## Chapter 4

# RESPONSES TO DSEIR COMMENTS

### 4.1 Master Responses to Comments on the DSEIR

**FIGURE 4.2-17. METHYLMERCURY (MeHg, µg/g, ww) IN COMPOSITE SAMPLES OF WATER STRIDERS (ORDER HEMIPTERA, FAMILY GERRIDAE) (N = 1-2) COLLECTED FROM THE HUMBUG CREEK/SOUTH YUBA STUDY AREA IN SEPTEMBER 2007 AND SEPTEMBER 2008**

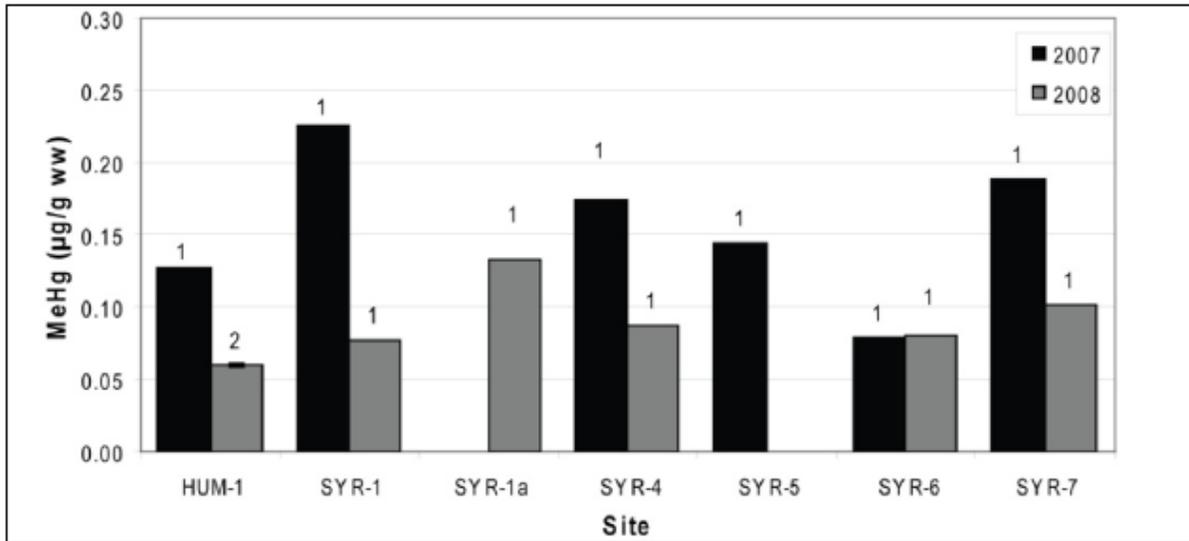
The studies on the levels of Hg in cadisfly and stonefly larvae appear to be statistically insignificant yet they are provided as statistically significant with a N=1 or 2. Even with such small samples the results do not indicate a degree of variability that would indicate that dredging is the proximate cause, nor that the variation can specifically be attributed to dredging. The worst case results in a difference of one one millionth of increase – yet the report can't discount water flows from the spring as causing this. The report actually discounts the cause of a spring flow event by using anecdotal evidence of "hydrologic conditions were very similar between these two years p.4.2-46, line 41."

Figure 4.2-17 from the SEIR used as evidence that dredging increases levels of Hg

Figure 4.2-14 from the SEIR

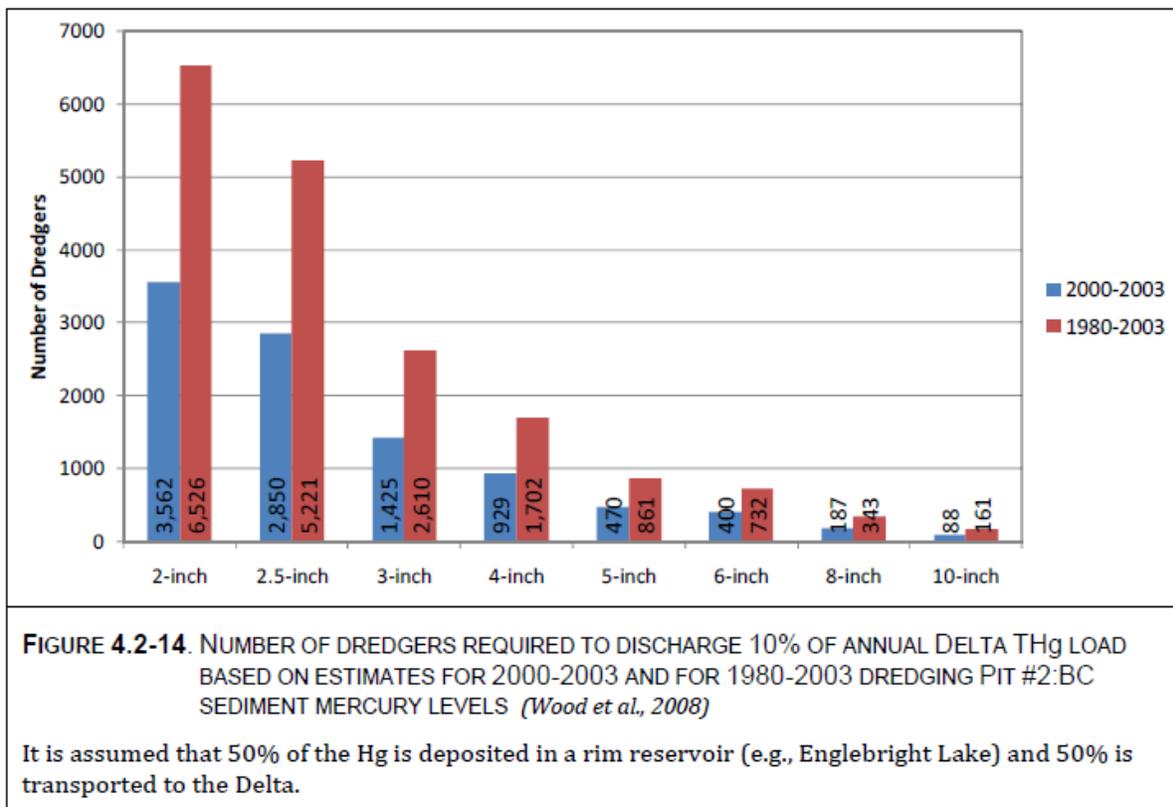
A third area of contention with the analysis of the data is provided in the extracted Figure 4.2-14 below. The SEIR attempts to estimate how many dredgers it would take to equal 10% of the assumed background Hg levels reaching the delta. The set up of this analysis is flawed, wildly unsupported and at best could be called spurious.

On page 4.2-42 the authors do not provide substantiation for how so much mercury laden sediment manages to transport over 30 miles to the nearest lake, given that earlier in the SEIR they clearly state that turbidity is zero within 100 meters of the dredge. It's not clear how the authors of the SEIR believe that a specific amount of Hg would reach the lake and what percent of this Hg would settle out during the course of the river, they do not discuss this, but instead leap to the conclusion that apparently 100% of the Hg reaches the lake where only 50% is dropped out, yet the other 50%, I assume it's MeHG is floated on top of the water, passes over the dam and manages to not precipitate or evaporate out at all during the remaining 100 miles of river. This is the assumption they base the graph on to declare that somehow dredging can produce the entire background load of Hg annually.

7 ↑ This analysis and conclusions appear to be the weakest part of the SEIR and utilizes strikingly weak data and analysis. The only conclusion the reader can reach is the authors of the SEIR are attempting to bolster a weak argument by preparing charts and graphs based on zero data, but instead are based on wild assumptions and guesses. The charts relating to the amount of Hg introduced into the river should be completely removed from the SEIR as they lack even a minimal amount of substantiating data and clearly show a bias towards results that apparently the authors want to achieve.

See MR-WQ-14. As stated in the assessment, data from Figure 4.2-7, which depicts the mercury bound to the  $\leq 63 \mu\text{m}$  particle size discharged from suction dredging, were used for these calculations. On page 4.2-40, justification is provided for why it was assumed that  $\leq 63 \mu\text{m}$  particles are transported to Lake Englebright, based on data from Curtis 2005. See also MR-WQ-3 and MR-WQ-7.

Figure 16. Chart from DSEIR estimating THg Discharge by Dredgers

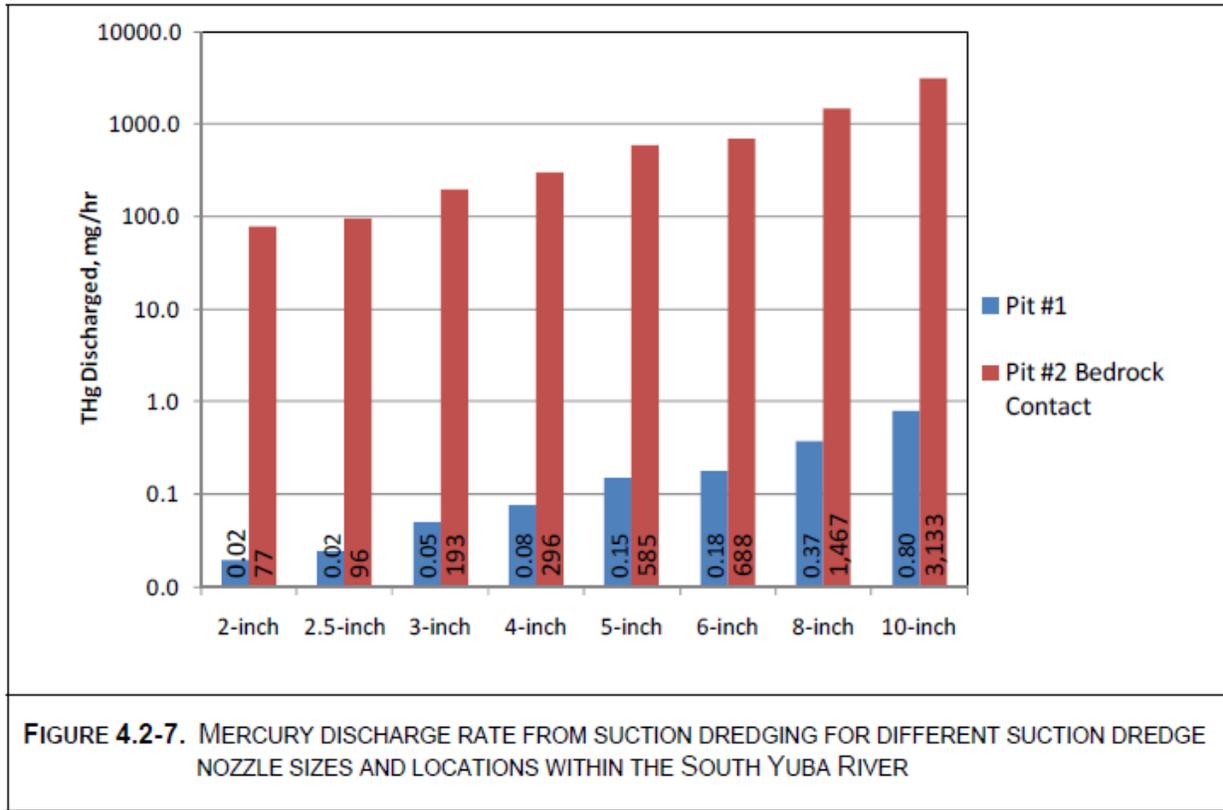
DSEIR, Figure 4.2-7 is shown below. This figure is important as it begins the discussion of how many dredgers would be required to produce the natural load for the watershed. Only using the figures for the 4" dredge we will use the same numbers to reach an alternate, but fact based conclusion.
